Title: **TOP & POWER**

Project: NUCLEO-XXXXXXX			
Size: A4	Reference: MB1136	Revision: C.3	
Date: 9/26/2014		Sheet: 1 of 4	life.augmented

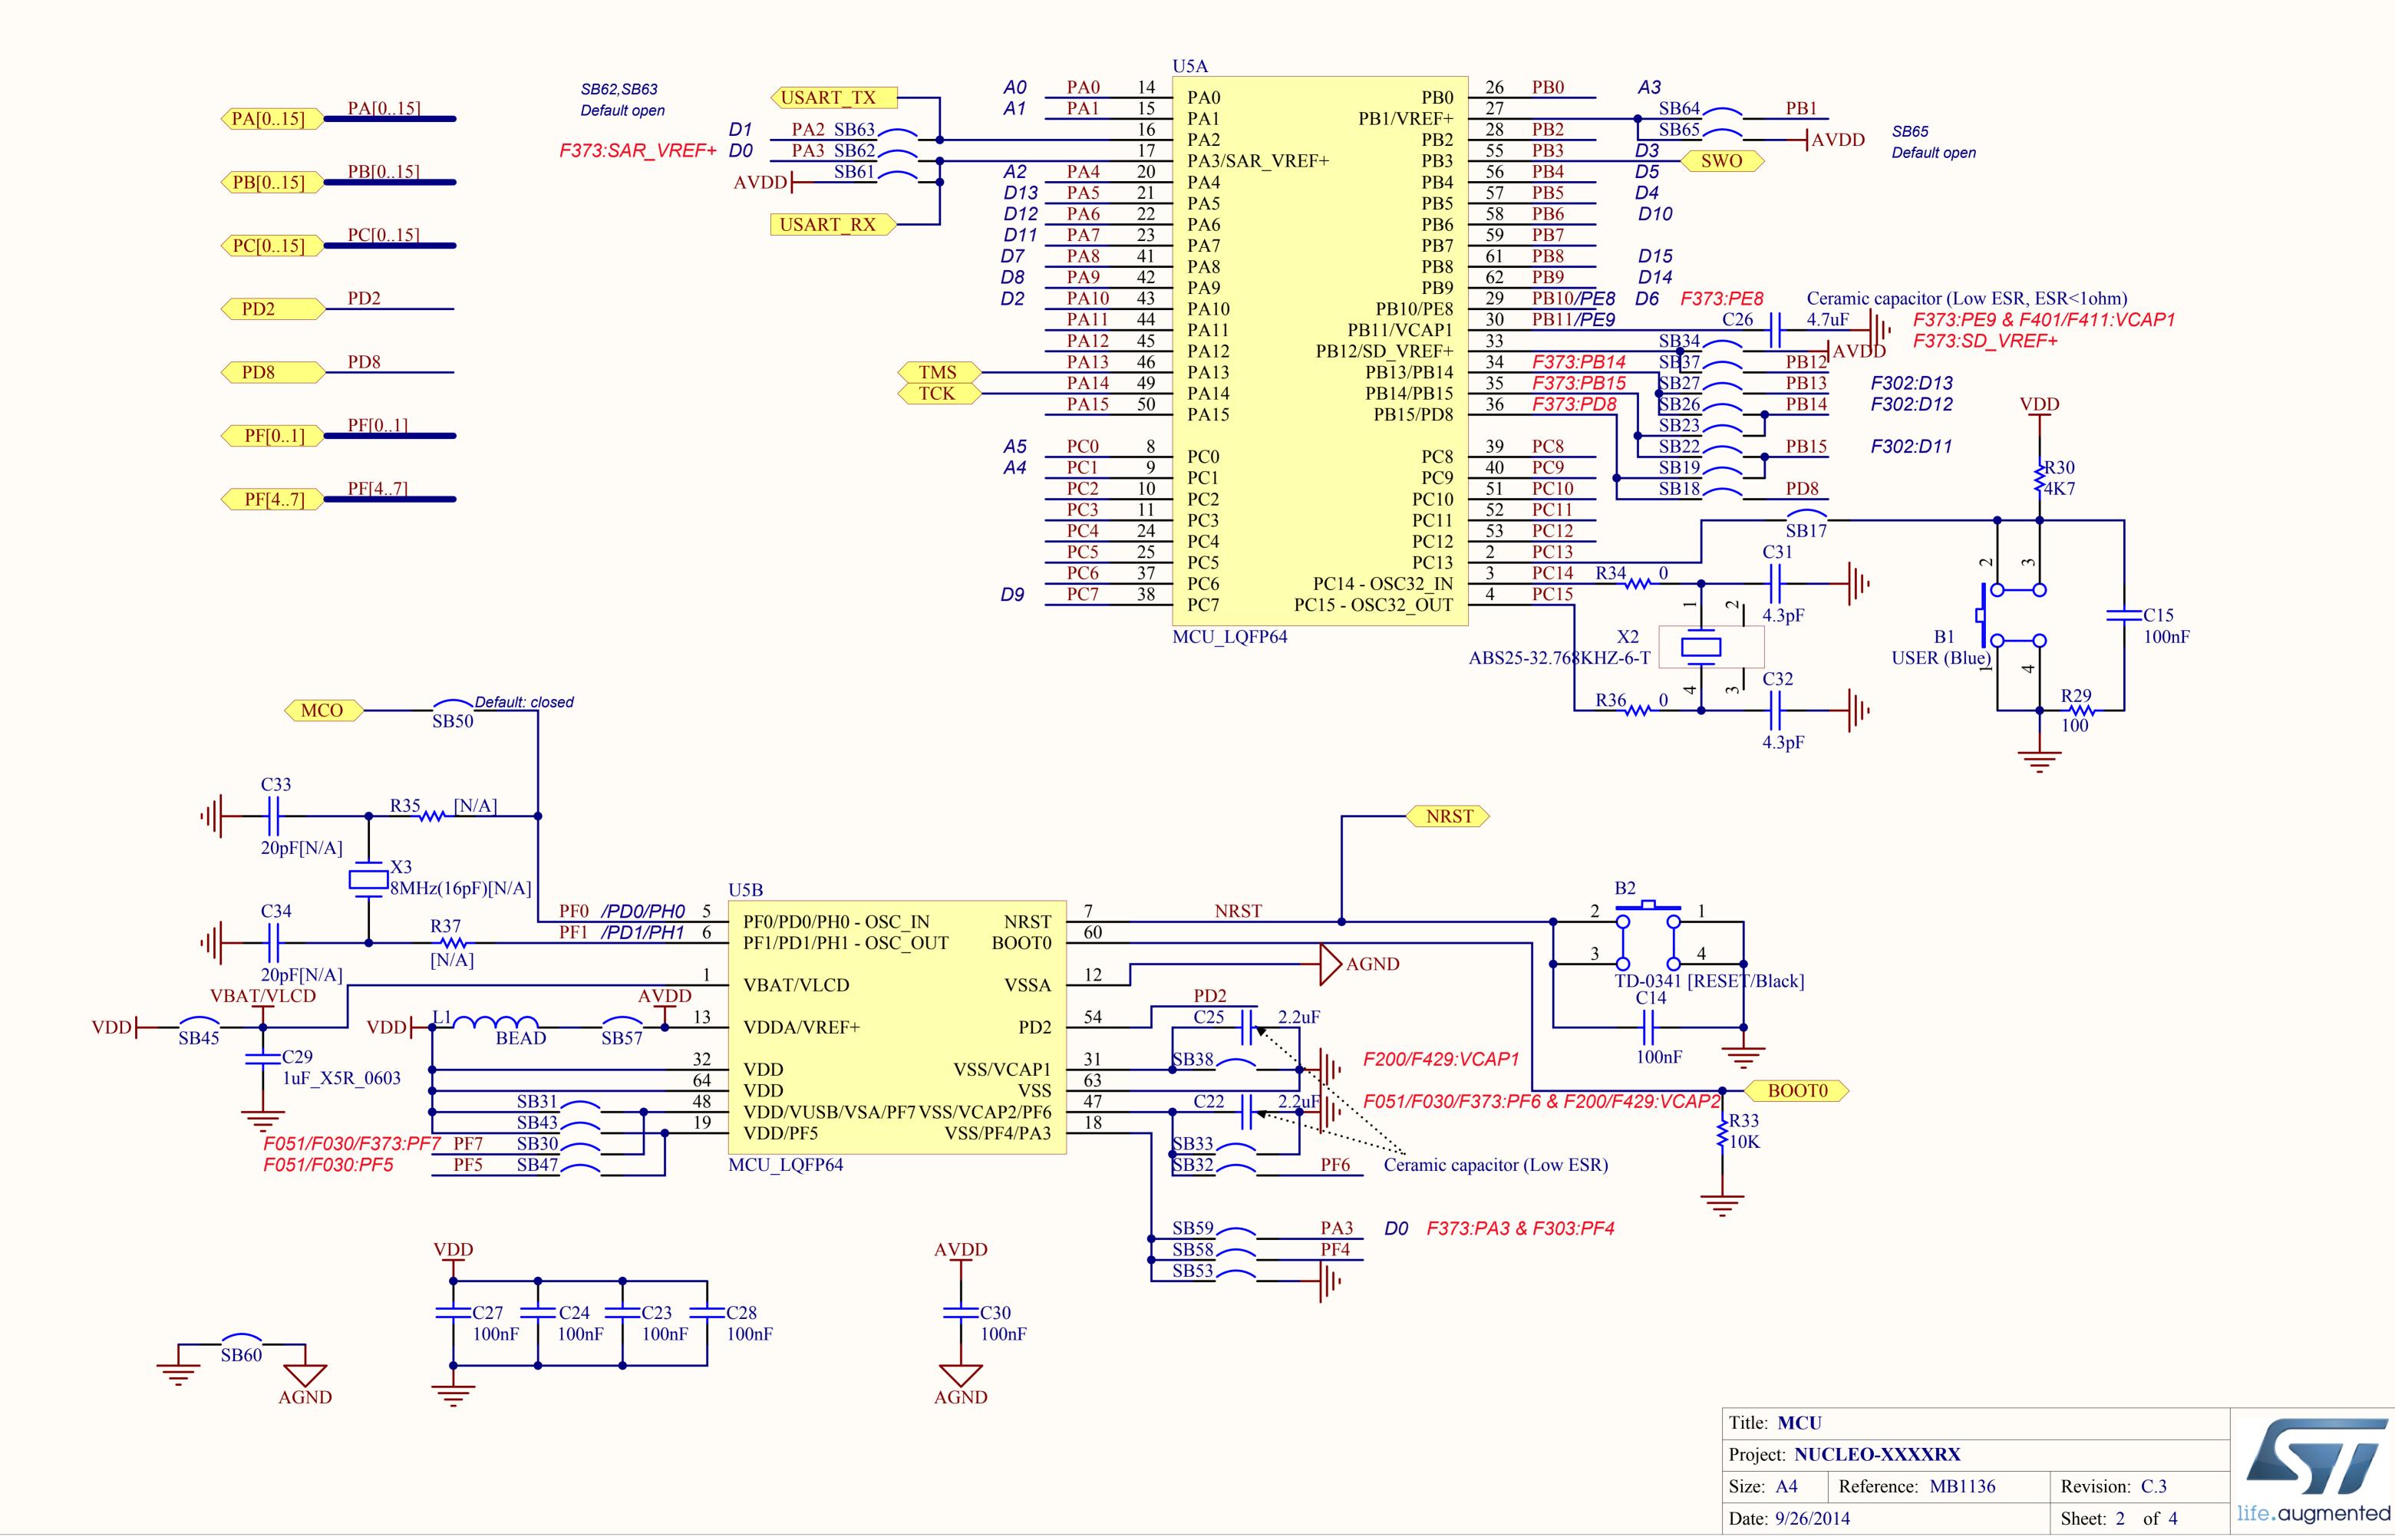
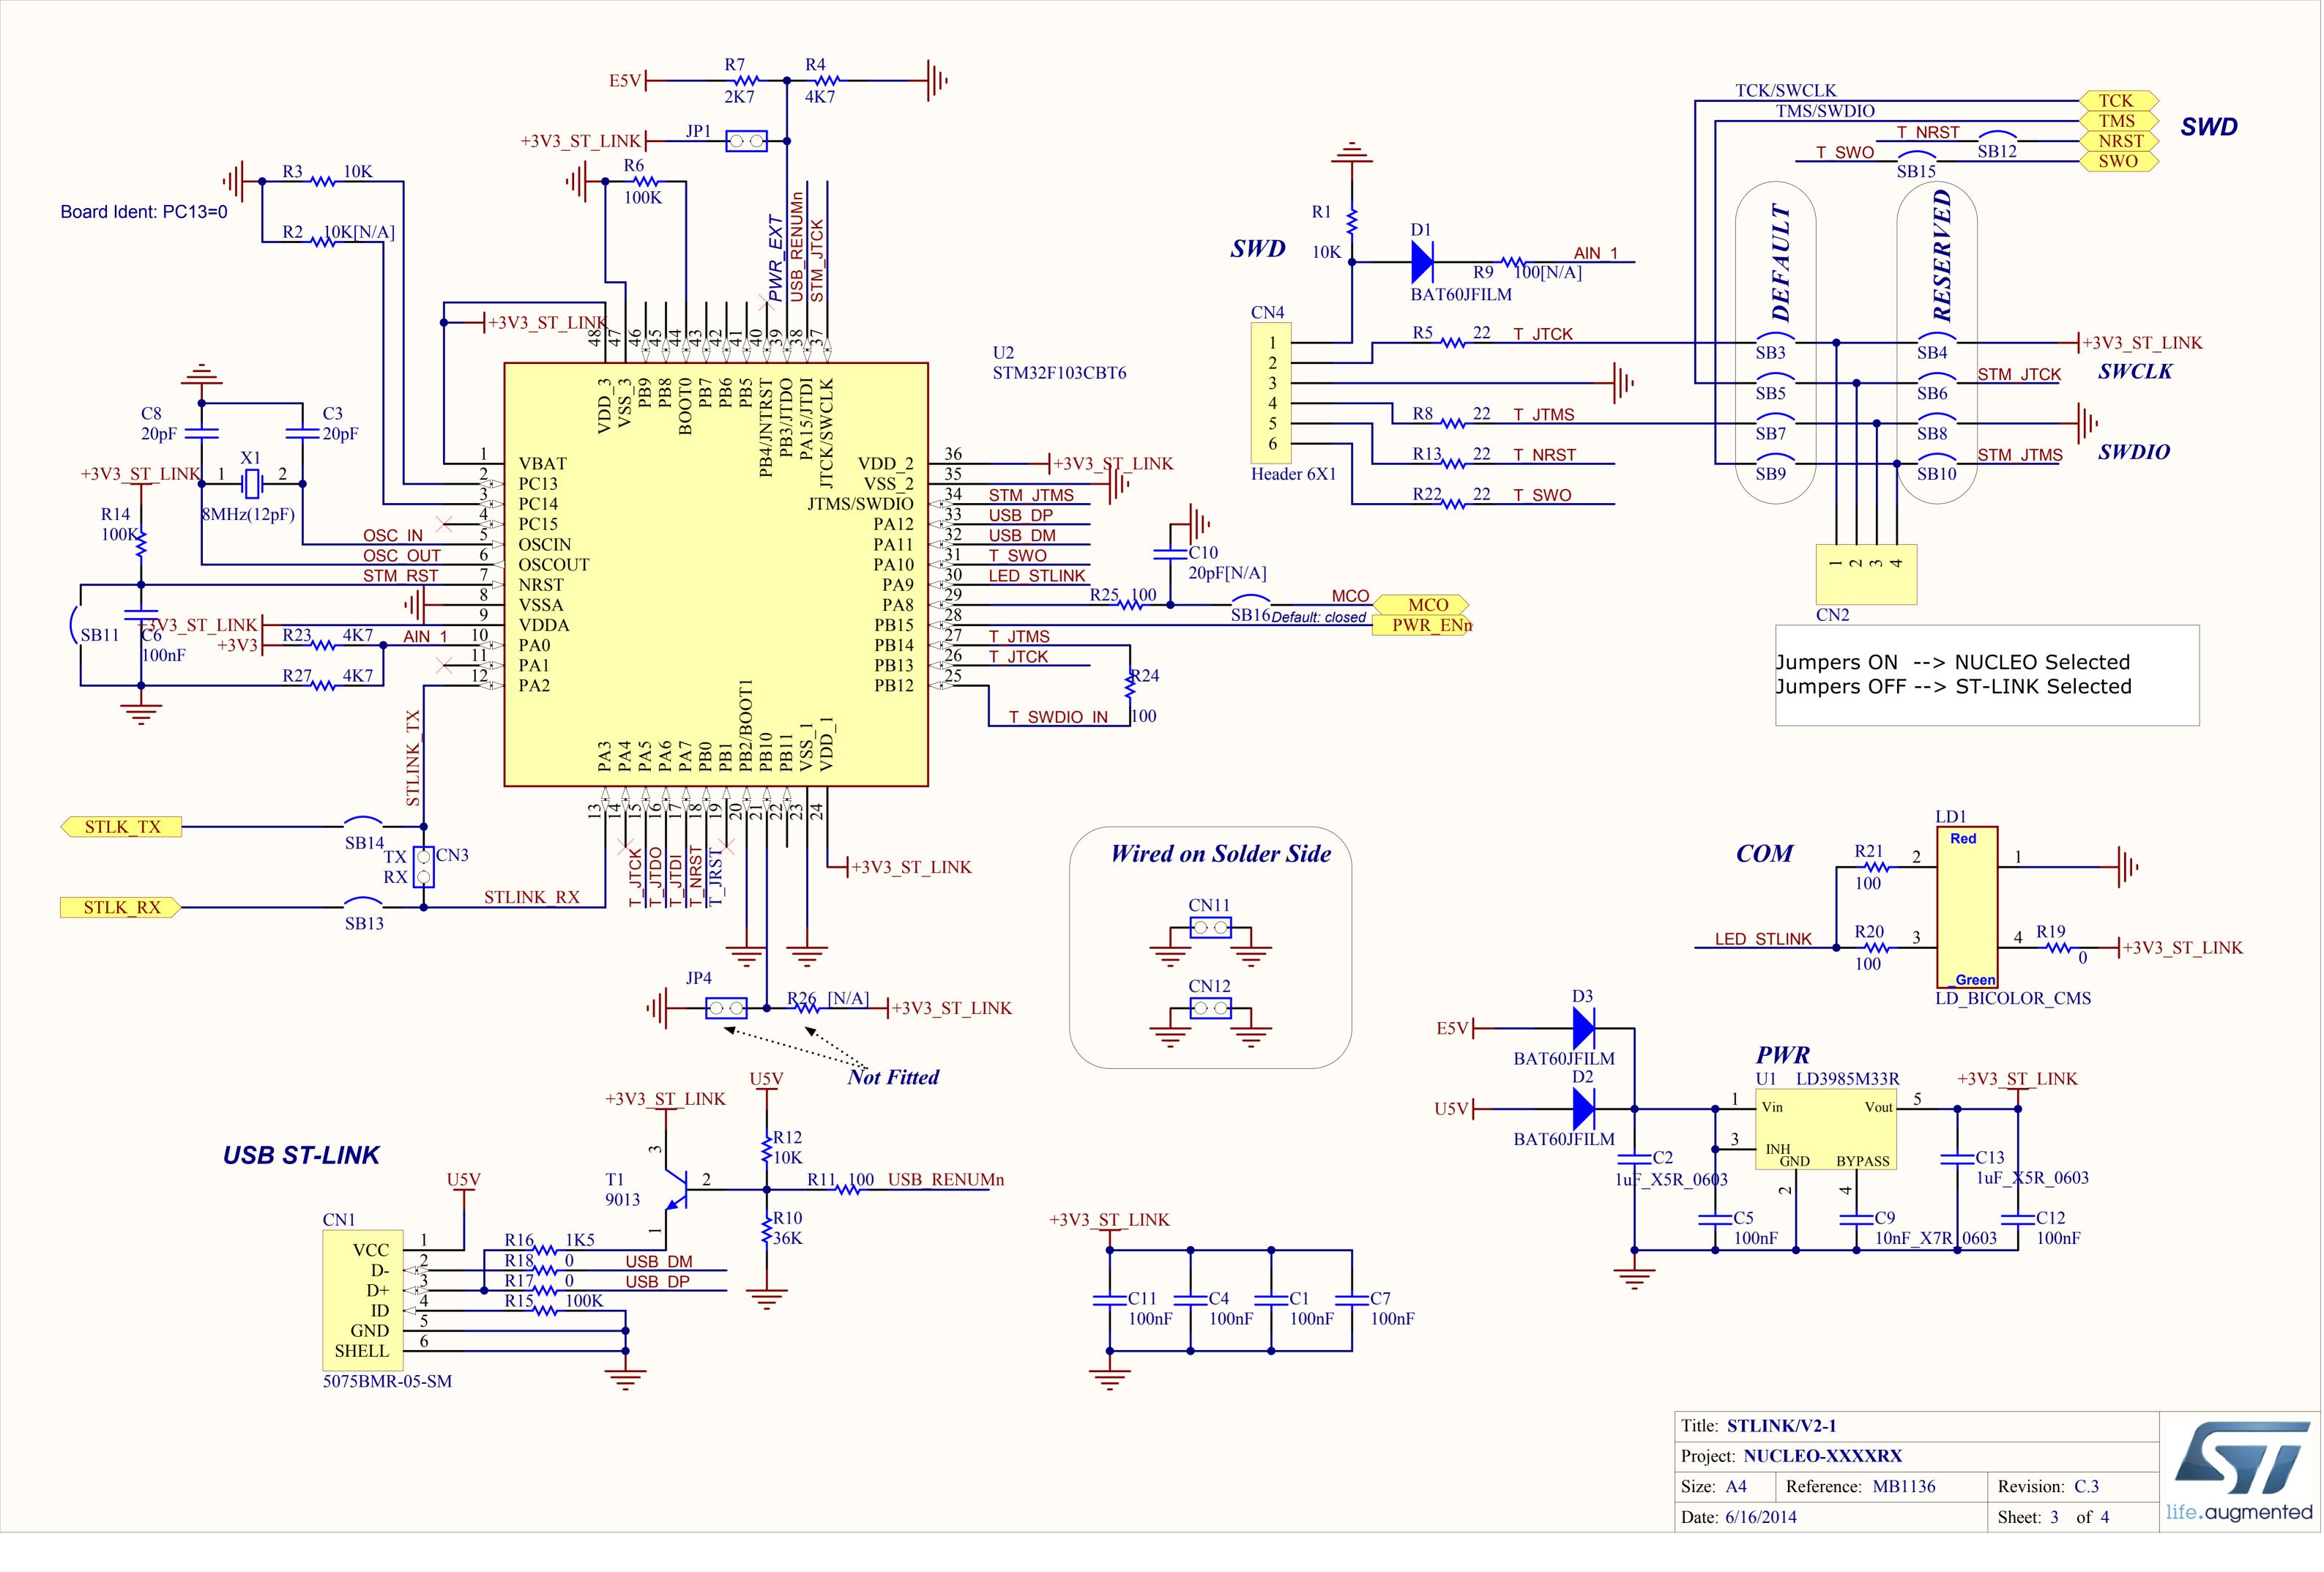
Note2: Remove [N/A] on R34, R36, C31, C32, X2 from C.1 to C.2

Note3: Add "default open" on SB48, SB49, SB55 from C.1 to C.2

Note4: Replace "default open" by "default closed" on SB16 & SB50 from C.1 to C.2

Note5: C31&C32 value changed from 10pF to 4.3pF to fit with new 32K crystal ABS25-32.768KHZ-6-T
